# UNITED STATES PATENT AND TRADEMARK OFFICE

APPLICATION NO.	FILING DATE	FIRST NAMED INVENTOR	ATTORNEY DOCKET NO.	CONFIRMATION NO.
10/773,076	02/05/2004	Michael Jeffery Doyle	DoYLE - rADoN	6028

# Office Action Summary

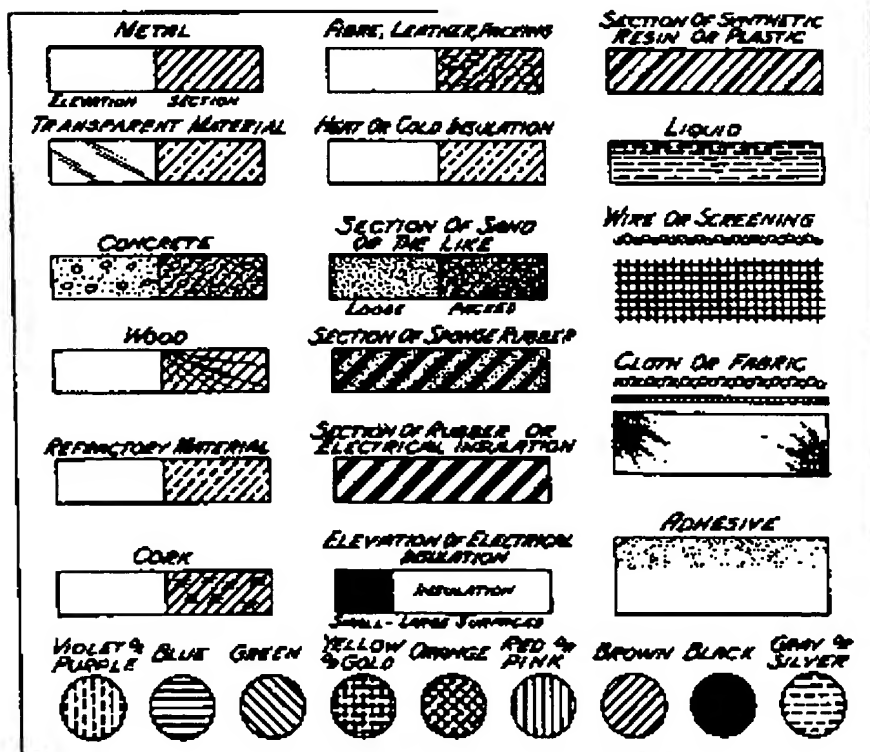
Fig. 4: Proper cross-sectional hatching is required to properly denote (1) concrete material for numeral 19 (see numeral 24 of Crawshaw (US 4,988,237) for a good example), and (2) "loose sand or the like" hatching (i.e., stone) (see below) for gas permeable material 20 in accordance with MPEP 608.02. The layers are incorrectly hatched for metal. See the drawing below for proper hatching examples.
